4. HD 6/15 M, HD 7/17 M, Cage and ST

Valve (3 ea.) (2.884-916.0),
Spacer (5.110-050.0/-079.0)

Service Bulletin

No. 2021-011 dated 08/02/2021

Fig. 1:

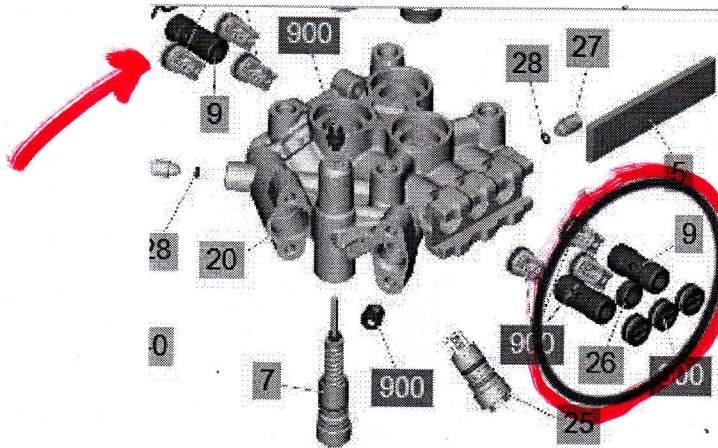
Cause: The suction and above all pressure valves (2.884-916.0) can be damaged, see Fig. 1.

Old spacers

Solution: Check and possibly replace pressure and suction valves.

Fig. 2:

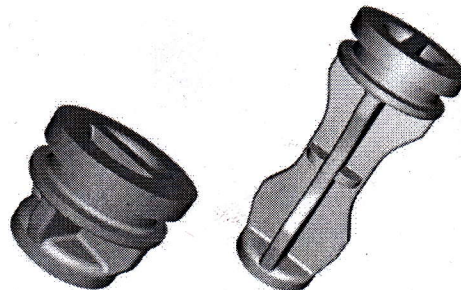
New plug, incl. O-ring

If the pressure valves were damaged, Fig. 3, the newly designed plugs (4.100-824.0/-825.0) made of plastic should be fitted, see Fig. 2. This offers improved support for the valve cages. The previously split spacers and plugs have been put together.

Fig. 3:

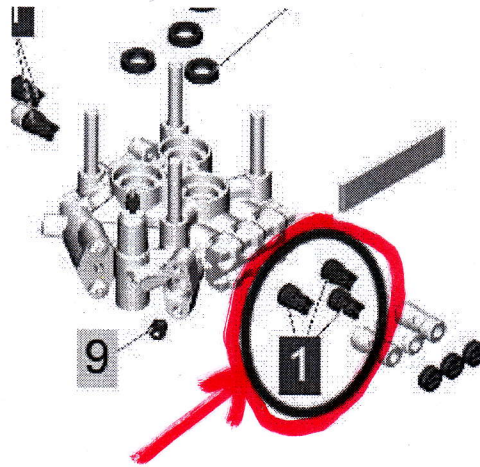
Pos. 1, valve (3 ea.)
2.884-916.0
